Access Compliance Report Public Rights-of-Way (Pedestrian Signals)

Main Street: MOUNTAIN_VIEW_AVE Cross Street: KELLOGG_DR Location: E

ADA ID: SGAT210922122833 Signal Type: Two Push Buttons-Non APS Overall Compliance: No Severity Scores: BTN 1: 35 BTN 2: 35 No BTN: N/A

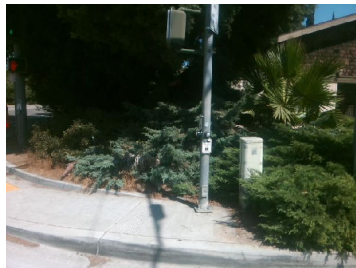
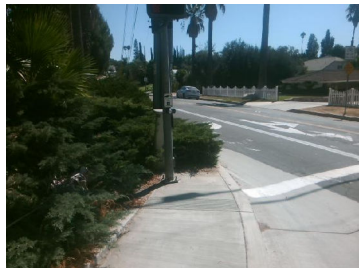
Yes B 1 Closed Fist Operation?	Yes	Yes	B 2 Closed Fist Operation?	Yes	
Yes B 1 Diameter (in)	2.25	Yes	B 2 Diameter (in)	2.25	
N/A B 1 Crossing Direction	SW	N/A	B 2 Crossing Direction	NW	
Yes B 1 DistanceTo XWalk (in)	5	No	B 2 DistanceTo XWalk (in)	84	
Yes B 1 DistanceTo Curb (in)	35	No	B 2 DistanceTo Curb (in)	144

Possible Solutions: Replace Signal Push Button With APS Button. Provide Clear Space. Remove & Relocate Sign.

OC Std/PROW: R404.1, MUTCD 4e.08
